RE: Fairway Estates, Resolution PC 21 39 SUB 03 and PC 21 40 PUD 02

Re: RESOLUTIONS PC 21 39 SUB 03 and PC 21 40 PUD 02 – Fairway Estates Preliminary Planned Unit Development (PUD) and Tentative Subdivision and AR 21 21 SIR 14 (Site Investigation Report)

## Phase 2 Western Edge

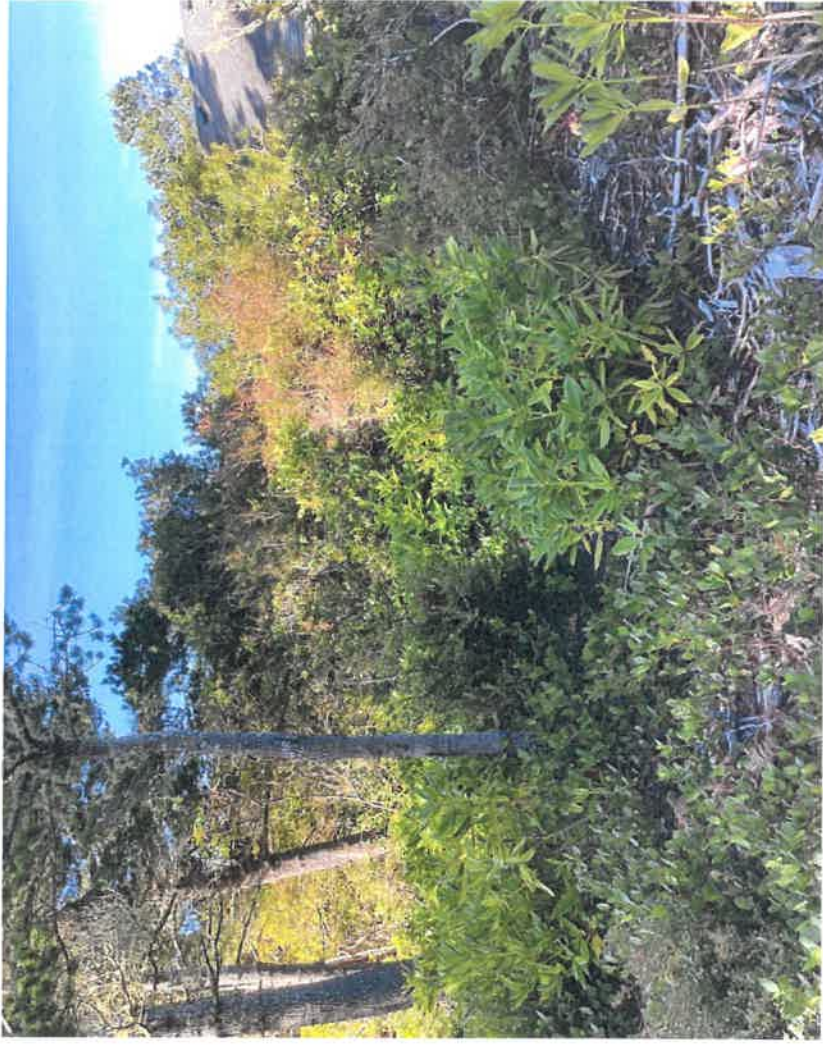
I believe the white pole may be the property line. The current proposal calls for clearing everything 10 feet to right of the pole.

# Wetlands

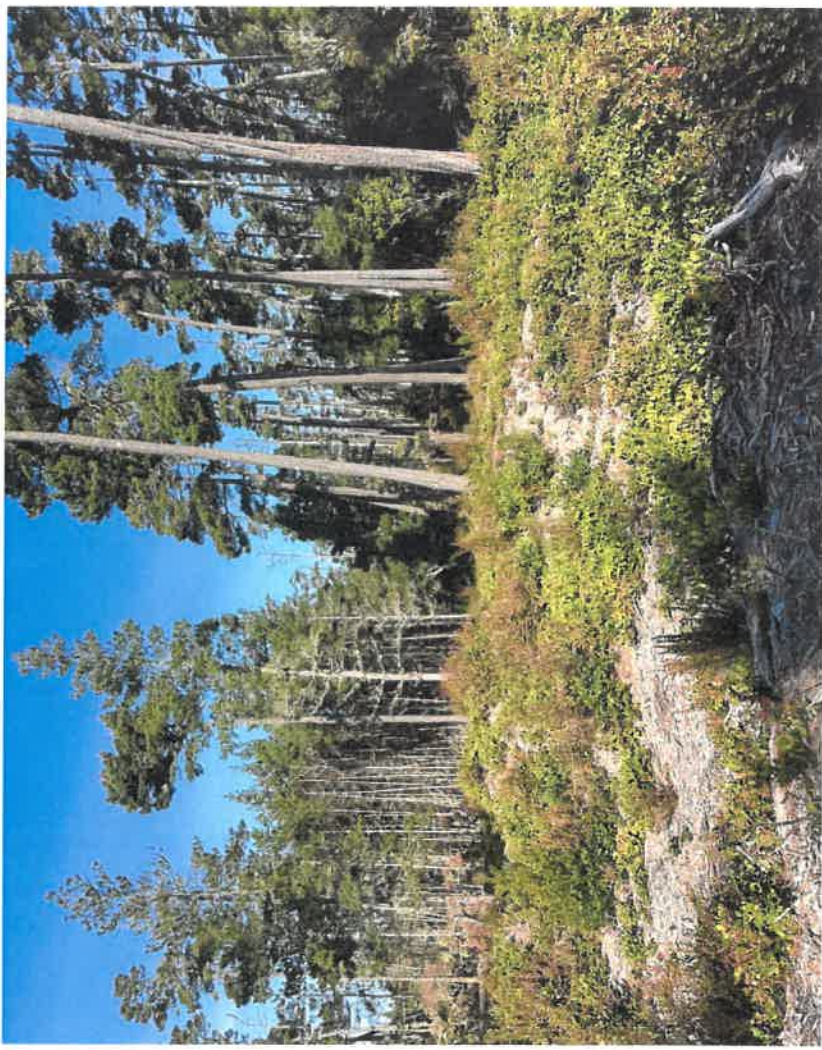
Moving along the northern border to the east towards the golf course is the area determined to have a small natural wetlands. This photo was taken April 27, 2023. You can see the blue tape in the lower right hand corner left by the researchers to mark the area. The wetlands area is not large enough to qualify for any governmental protection and the developer has applied to provide funding for other wetlands and fill this in to build houses here. I think it's one of those special places that just calls out for contemplative reflection. I'd like to see it preserved. My original ideas are contained in what is now Exhibit R3 in the Supporting Documents of the application.

Another view of the wetlands.
